Re: Impasse Appeal by Cities of Culver City and Ontario, and County of San  
Bernardino - Project No. R2013-00396-(2); Aviation Case No. 201300001 -  
General Plan and Specific Plan Amendment Project (City of Los Angeles)

Re: Draft Environmental Impact Report for the Los Angeles International Airport  
Specific Plan Amendment Study - Comments of City of Inglewood, City of  
Culver City, City of Ontario and County of San Bernardino

Figure 1a. Example EDMS (B747-400) Emission Rates by Operational Mode

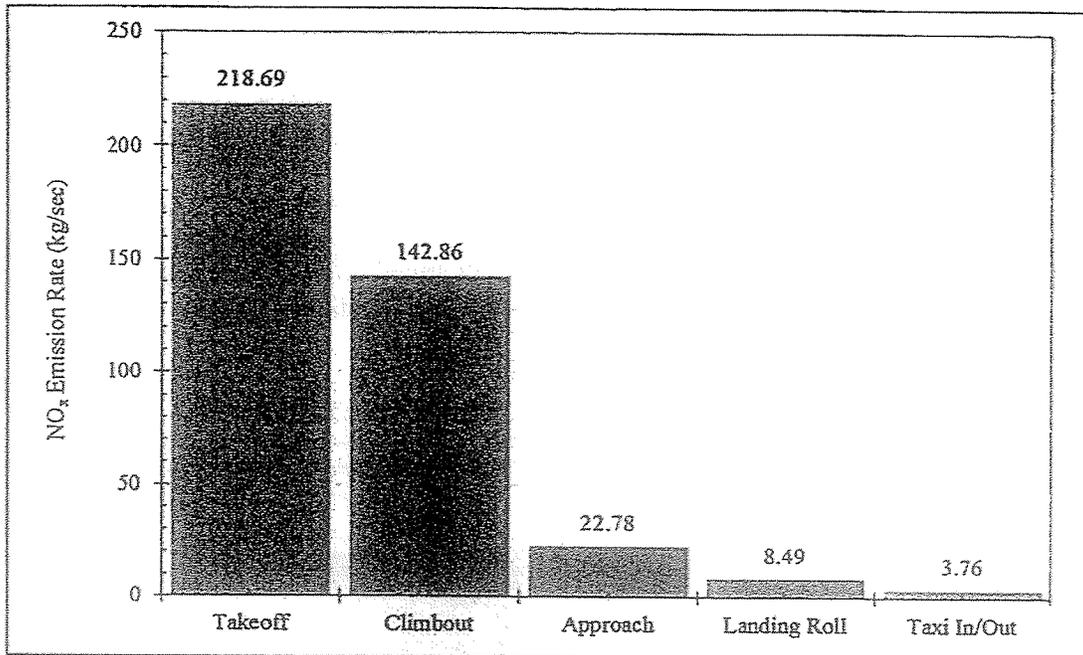
Figure 2a demonstrates that the duration of the entire landing roll operational mode is less than 15 seconds. The reverse thrust operation alone would generally endure for that entire period. Moreover, in Figure 3a, which depicts the second-by-second data for the aircraft operating modes, the transition from approach to landing roll operations clearly reflects the absence of any NO<sub>x</sub> spike of any duration associated with the B747 landing roll.

Figure 1b. Example EDMS (B737-800) Emission Rates by Operational Mode

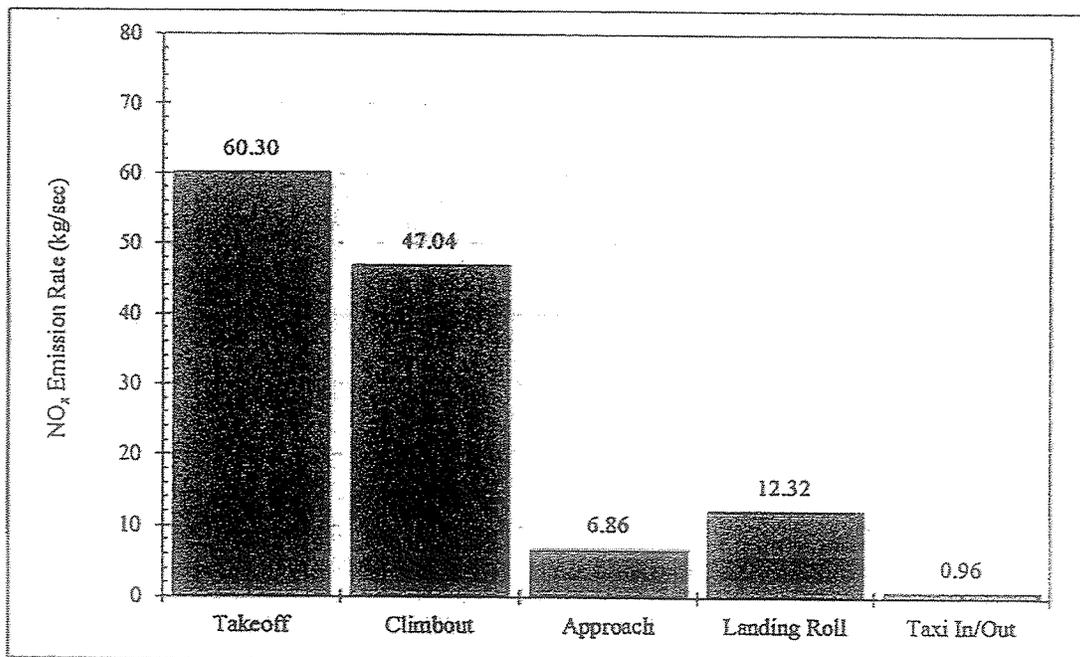
The results are somewhat different for the B737. Figure 1b demonstrates a minor increase in landing roll NO<sub>x</sub> from approach thrust, but this increase is far lower than the high thrust operations that would normally be expected from reverse thrust.

Figure 4a. Example EDMS (B747-400) Relative Thrust (as NO<sub>x</sub>) by Mode

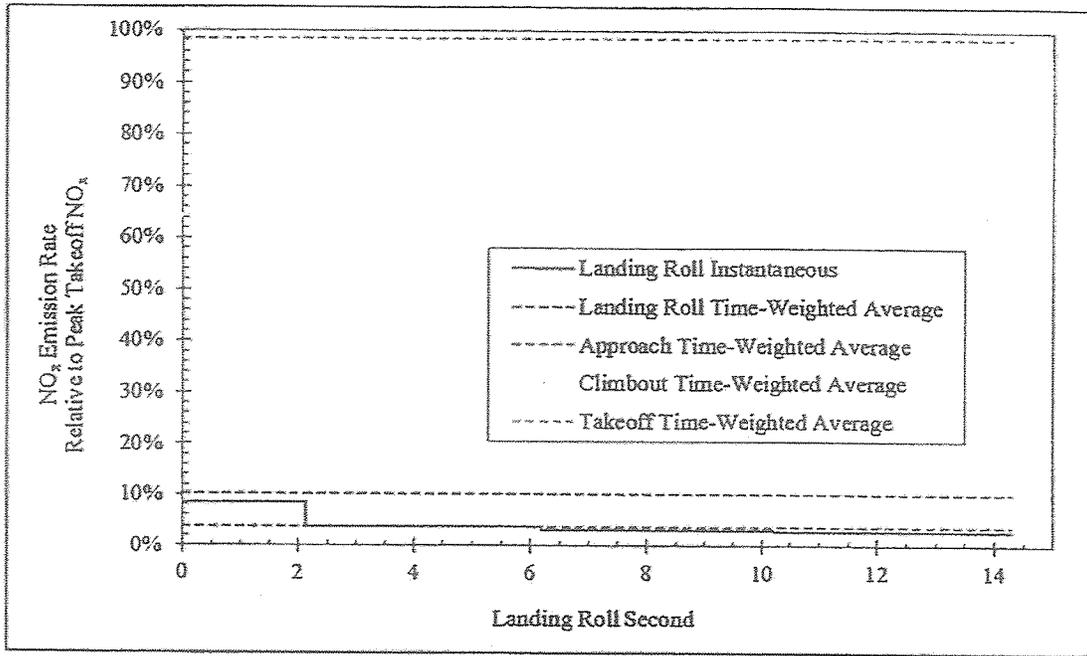
Figures 2b and 3b show that, as was the case for the B747 example, the “muted” effect does not result from any landing roll averaging. In fact, the thrust increase is fairly constant across the complete 17 second landing roll, as depicted in Figure 4b.
